Architectural Review
and Historic Preservation Board
Agenda Report

File : AR 15-01

RE: Southeast Chico Primary Care Clinic
Northwest corner of East 20th Street at Concord Avenue in Meriam Park

"UL" - UPLIGHT FOR TRELLIS DOUBLE
COLUMNS - 3000 COLOR TEMP

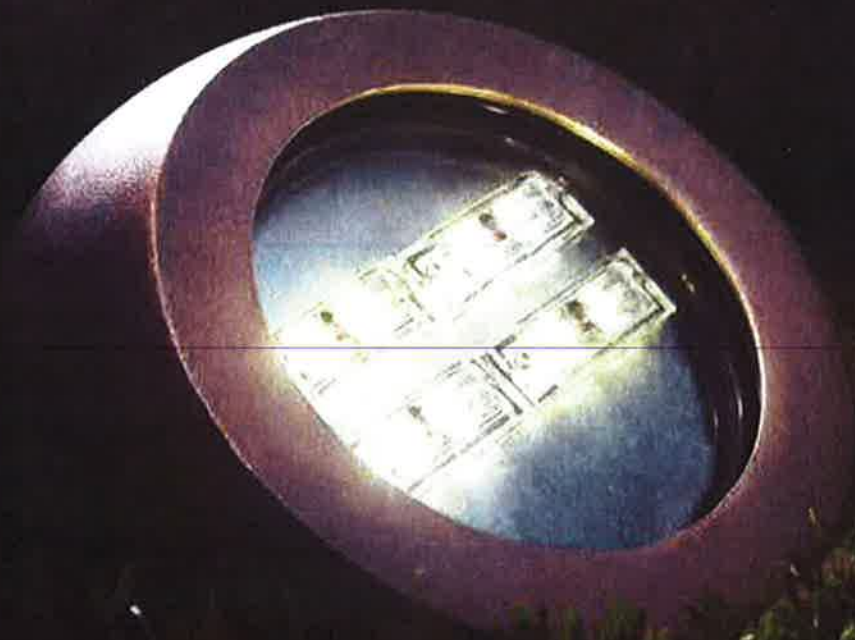
As noted above, the plan calls for several types of lighting, including ground-mounted uplights to illuminate various roundhouse features and roof-mounted screen lights to shine up onto the mechanical unit screen walls. These two types of lights are not consistent with CMC 19.60.050

(Exterior Lighting), which states in part that “[e]xterior lighting shall be architecturally integrated with the character of all structures, energy-efficient, and shielded or recessed so that direct glare and reflections are confined, to the maximum extent feasible, within the boundaries of the site. Exterior lighting shall be directed downward and away from adjacent properties and public rights-of-way.” In addition, Mitigation Measure AES-1 from the Meriam Park EIR requires new lighting to minimize spillage and atmospheric light pollution (see **Attachment N**). A condition is recommended that would require removal of these two types of upward-directed lights, and would permit substitution with different types of lighting in these areas that comply with code requirements.

Discuss if alternative, downcast lighting is acceptable to illuminate the mechanical screen walls as provided by recommended condition #4, or if such lighting is not appropriate. Modify condition #4, if needed, to make the required findings for approval.

4. The ground-mounted uplights (UL on the site plan) and roof mounted mechanical screen lights (SL on the site plan), shall be removed from the project. Alternative types of lighting that comply with code requirements may be substituted in these areas on the building plans, subject to staff approval.
